**PLANNING COMMISSION REPORT**  
**Regular Agenda – Public Hearing Item**

**ITEM NO. 2                      SPECIAL USE PERMIT FOR LMH; W. 3rd & MICHIGAN ST (SLD)**

**SUP-18-00363:** Consider a Special Use Permit/Institutional Development Plan revision for the Lawrence Memorial Hospital for a 6,924 square foot Sterile Processing & Distribution Addition on the east side of the hospital building, located at 325 Maine St. Submitted by Landplan Engineering on behalf of Lawrence Memorial Hospital, property owner of record.

<p><b>Figure 3: Approved plan SUP-17-00153</b></p>		<p><b>Figure 4: Proposed addition and parking lot changes</b></p>

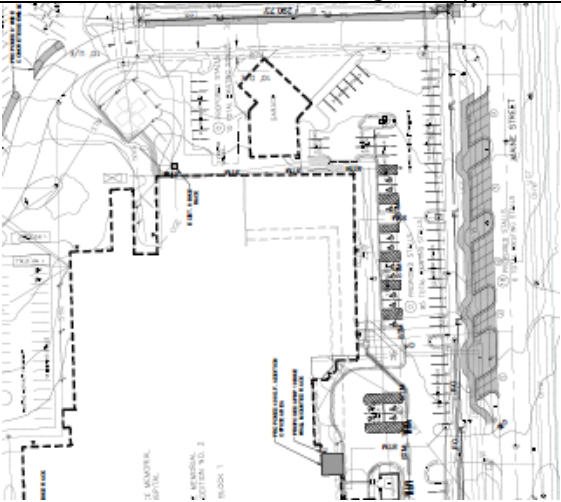
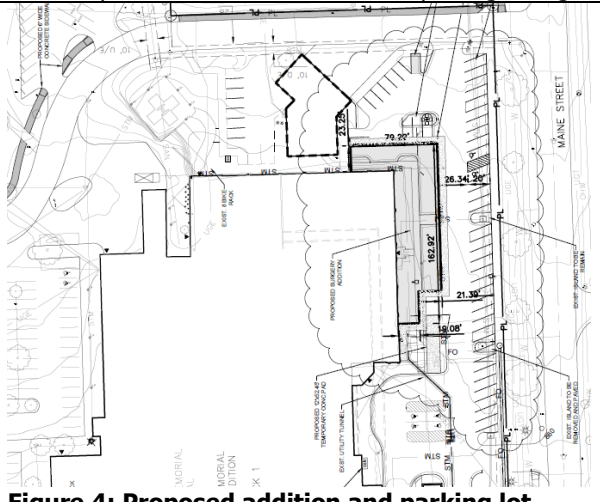
The plan notes that this area includes 95 total parking stalls. The revised plan reduces the parking in this area to 76 spaces. The spaces in this area provide parking for the main emergency entrance to the building.

**Figure 5: North cut-through**

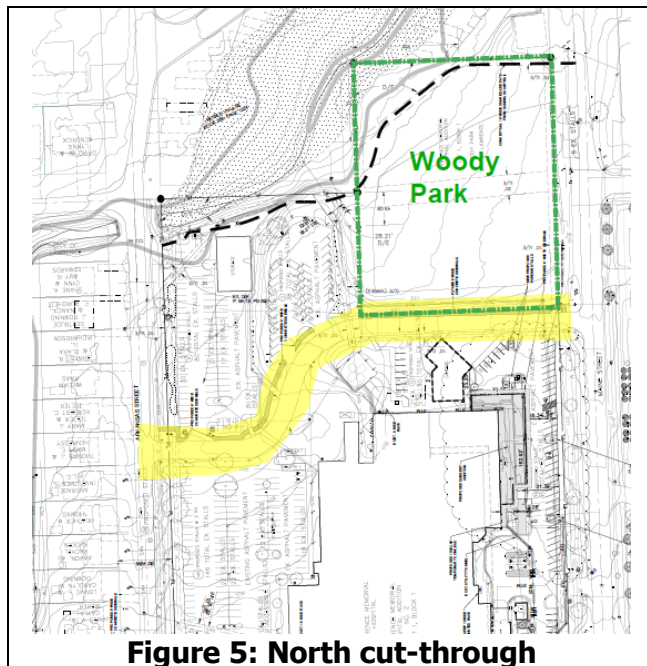
- Access to the east side of the Hospital facility is not altered with this application.
- The existing drives are not modified with this application.
- The parking at the north end of the site will be oriented for one-way traffic with angled parking where the access drive narrows because of the building addition.

Appropriate signage and pavement markings will be needed to direct traffic flow. The driveway along the north side of the *Hospital*, located between Arkansas Street and Maine Street, is an active neighborhood throughway in addition to the public street network surrounding the Lawrence Memorial Hospital.

**Pedestrian accessibility:** The plan shows a new sidewalk along the north side of the access drive in the north portion of the development shown in figure 5. The plan notes states "Future 6 foot wide concrete sidewalk." The project does not commit to that construction. The existing access drive is 25 feet wide. The sidewalk would be located back of curb with no separation from the street. The access drive is not a public street but is used for cut-through traffic and is blocked when the heliport is in use.

**Figure 6: Lawrence Loop**

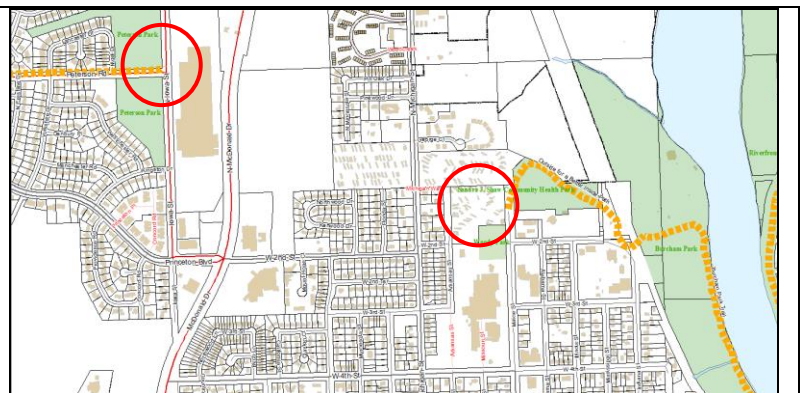
The Hospital property is located along one of the three route options identified for the Lawrence Loop connection study. A link to the study is referenced in the beginning of the staff report. North of the Hospital property is the Sandra Shaw Trail (Outside for a Better Inside Trail). The trail currently terminates at the end of Maine Street. A 10 foot shared use path connection may need to cross the Hospital property, Woody Park or another alignment in the immediate area. This plan shows a 6 foot wide sidewalk along the north side of the access driveway on the south edge of Woody Park. The width and design of the sidewalk would not meet the requirement for the 10 foot shared use path.

**Figure 7: Proposed Building Elevation**

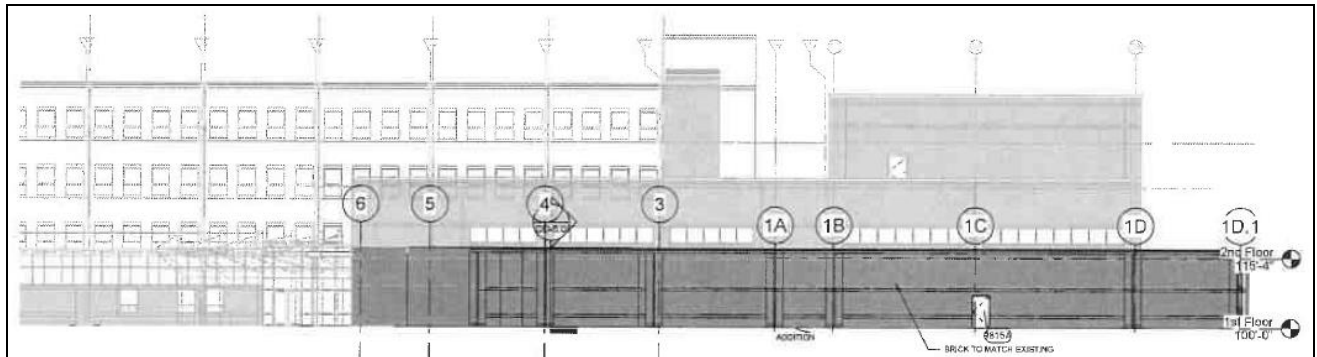
**Building Elevations:** The proposed addition includes two stories with an intent to match the existing brick pattern of the building. Windows are not proposed along this building segment. The building is not subject to the Community Design Manual for commercial or industrial design standards.

***Mechanical Equipment Screening:*** Mechanical screening is not proposed with this addition. Any rooftop or building mounted mechanical equipment will need to be appropriately screened. Staff will continue to review this element with a future building permit applications.

**Figure 8: Bufferyards**

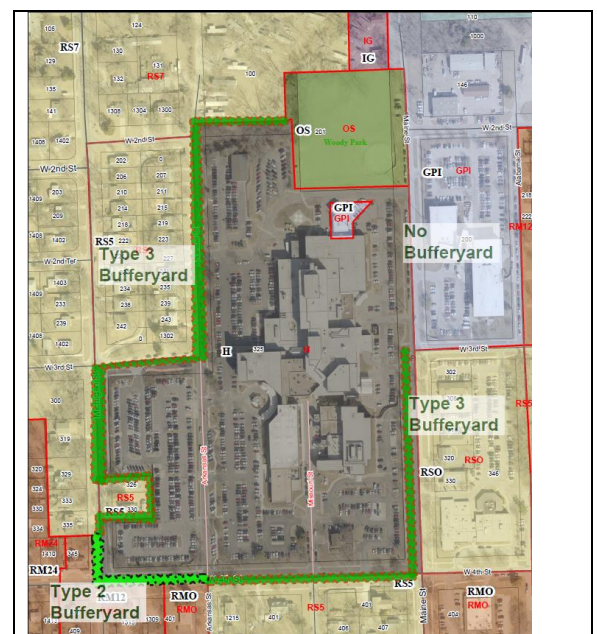
**Bufferyard:** A Type 3 Bufferyard is required along the H district that abuts an RS district. This standard is applicable to specific portions of the property that are not affected by the proposed addition. The area north of W. 3<sup>rd</sup> Street along Maine Street is zoned GPI. Uses along the east side of Maine Street in this location are comparable in use and intensity. A buffer yard is not required in this location.

**Figure 9: Interior Greenspace**

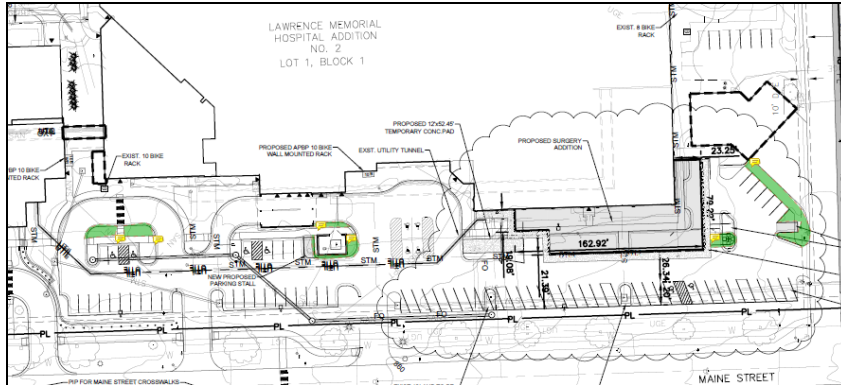
**Interior Landscaping:** Development of the various parking lot surrounding the Hospital have occurred at different times with a variety of requirements for interior parking lot landscaping. This section of the report focuses on the parking lot located along Maine Street south of Woody Park. The majority of parking is located along the Maine Street. There are only small pockets of parking spaces that are interior to the parking lot. The required interior landscape area to support the 76 spaces is 3,040 square feet. This plan shows approximately

2,144 square feet in this area. Some existing interior landscape islands are being removed and replaced with parking to mitigate the overall amount of parking on this side of the Hospital. The remaining island areas are small and generally not suitable for trees and shrubs. Previous plans did not require trees and shrubs in this part of the parking lot.

**Figure 10: Existing Parking Lot Perimeter Screening**

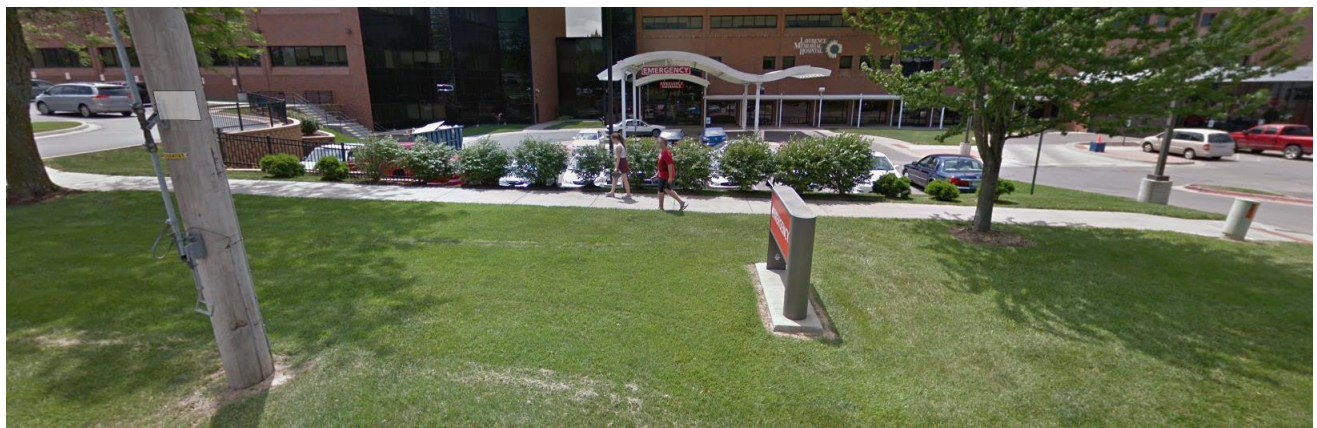
**Perimeter Landscaping:** The parking lot setback along Maine Street was included in a variance approved in 2006 (B-4-13-06) that allowed a reduction from the required 25 foot setback to 8-15 feet setback as shown on the plan. The segment located at the north end of the site was reduced to 8 feet. Parking in this area is revised from parallel to angled parking. This revision does not include any parking lot screening.

The site plan that included the original parking lot showed a continuous row of shrubs along the back of the curb to screen the parking lot. The only shrubs that were installed are located in front of the emergency entrance. This portion of the parking lot is below the street grade. The grade change provides a natural screening to the parking along this segment of the street.

**Figure 11: SP-09-75-06 Approved Site Plan**

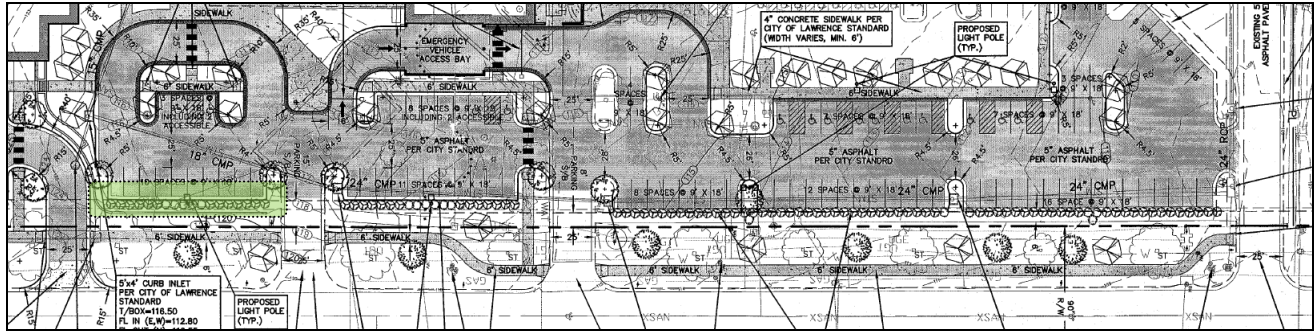
The 2006 site plan also showed trees in addition to the minimum street tree requirement. The additional trees shown in the 2006 plan do not exist. The lack of trees may be related to a Westar overhead electric improvement along Maine Street that removed or reduced the number of trees to accommodate the aerial equipment. Figure 11 highlights in green the location of existing shrubs along Maine Street. The applicant has revised the drawing to show new landscaping material added along the parking lot affected by the proposed building addition.
